METROPOLITAN GOVERNMENT OF NASHVILLE AND DAVIDSON COUNTY

STAFF RECOMMENDATION
1103 Montrose Avenue
July 15, 2020

Application: New Construction—Outbuilding (Detached Accessory Dwelling Unit)
District: Waverly-Belmont Neighborhood Conservation Zoning Overlay
Council District: 07
Map and Parcel Number: 11801013400
Applicant: Beau West
Project Lead: Melissa Baldock, melissa.baldock@nashville.gov

Description of Project: Application is to construct an outbuilding to be used as a Detached Accessory Dwelling Unit

1 SITE PLAN

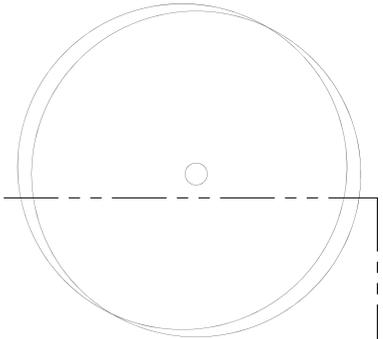
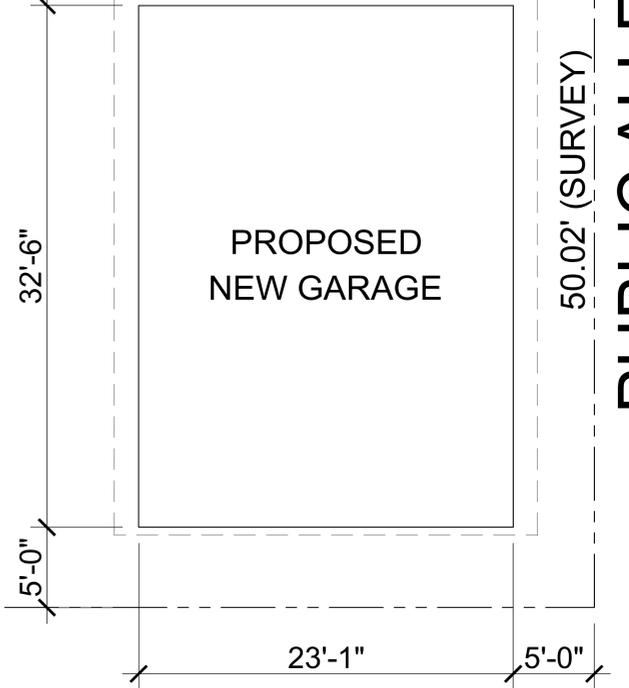
MINIMUM	PROPOSED
Space between principal building and DADU/Garage	20'	35'
Rear setback	5'	5''
L side setback**	5'	12'
R side setback**	5'	5'
How is the building accessed?	From the alley or existing curb cut	Alley

Staff finds that the proposed setbacks meet Sections III.H.6 and 7 of the design guidelines.

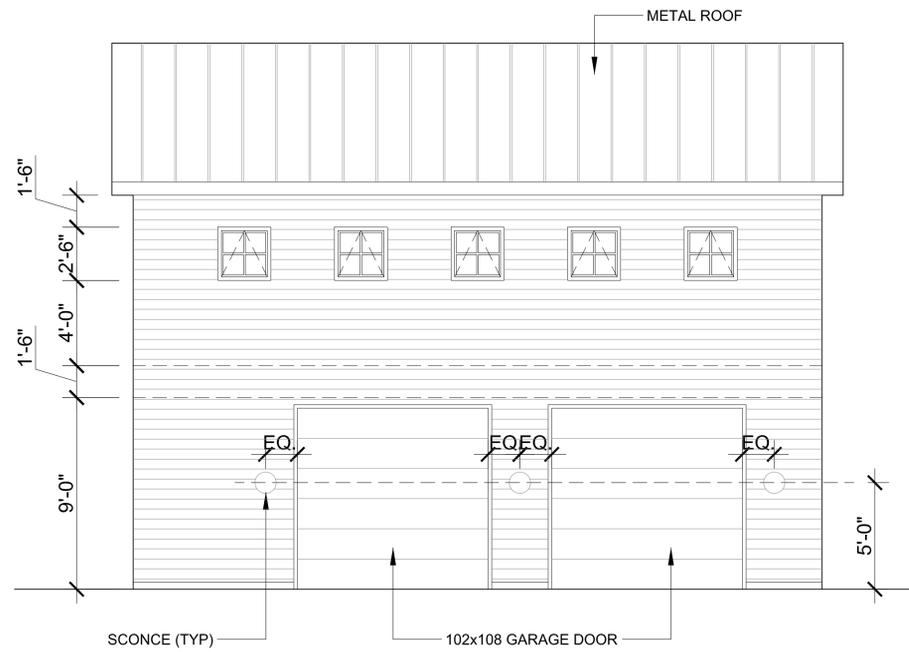
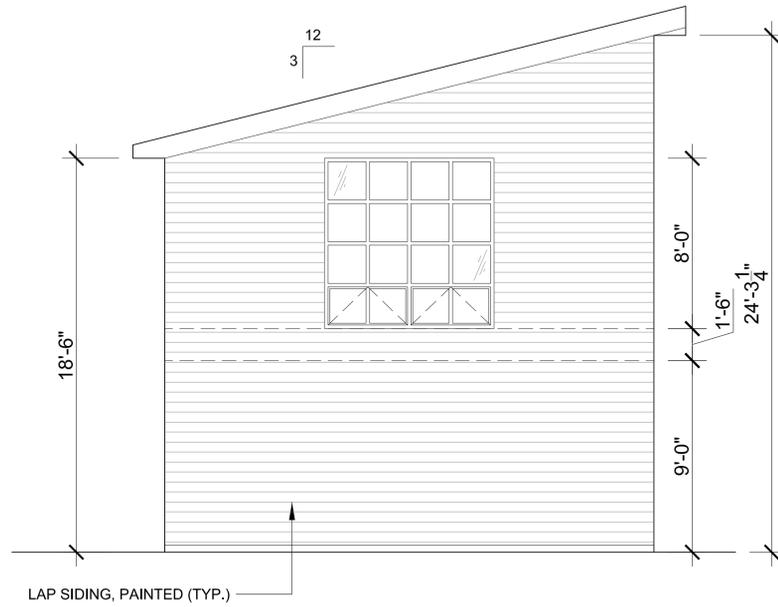
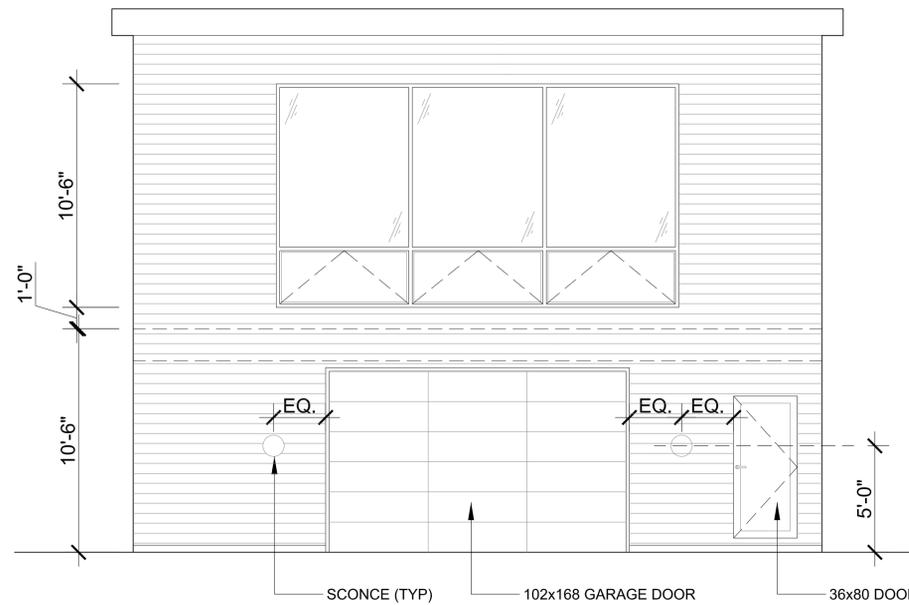
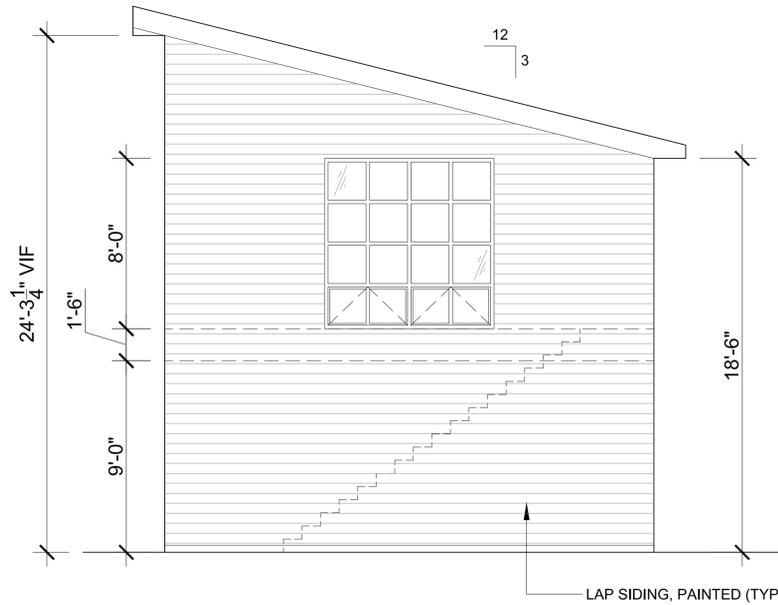
Analysis and Findings: Application is to construct an outbuilding to be uses as a Detached Accessory Dwelling Unit. The applicant proposes a two-story structure behind a one-story historic house.

The historic house is one-story in height, although the 2017 addition is two stories in height. For the sake of new garages and DADUs, MHZC looks at the height and scale of the historic house. Staff therefore finds that the proposed two-story DADU with eave heights several feet taller than the eave height of the historic house does not meet the design guidelines nor the DADU ordinance.

The DADU ordinance states, “The detached accessory dwelling shall maintain a proportional mass, size, and height to ensure it is not taller than the principal structure on the lot. The detached accessory dwelling height shall not exceed the height of the principal structure as measured to the eave line, with a maximum eave height of ten feet for single-story and seventeen feet for two-story detached accessory dwellings.”

In this case, the massing and eave height is significantly taller than that of the historic house. Since the historic house is one-story, the eave height of the DADU should be ten feet (10'). (The proposed eave height is even greater than what would be allowed on a two-story outbuilding.) While the overall ridge height of twenty-five feet (25') meets the design guidelines and the DADU ordinance, the eave height and two-story massing does not meet Section H.1.c. of the design guidelines and Section 7.d. of the DADU ordinance (17.16.030.G.).

The Commission has allowed shed roof forms for outbuildings when the lower slope edge of the roof overhang met the maximum eave height and the higher slope met the maximum ridge height. However, in this case, the lower eave height is significantly taller than the eave height allowed for a DADU behind a one-story house like this. A shed roof form could be appropriate, if the lower eave were ten feet (10') or less.

The design guidelines also state that the minimum roof slope for an outbuilding is 4/12, and the proposed roof slope is just 3/12. Staff therefore finds that the proposed roof form does not meet Section III.H.3.b. of the design guidelines.

Design Standards: Staff finds that the two-story scale, the tall eave height, and the low slope roof form creates a design that does not meet Section III.H. of the design guidelines nor Section 17.16.030.G., the DADU Ordinance.

Recommendation Summary: Staff recommends disapproval of the project, finding that the proposed building’s scale, eave height, and roof form do not meet Section III.H. of the design guidelines for the Waverly-Belmont Neighborhood Conservation Zoning Overlay and Section 17.16.030.G., the DADU Ordinance.
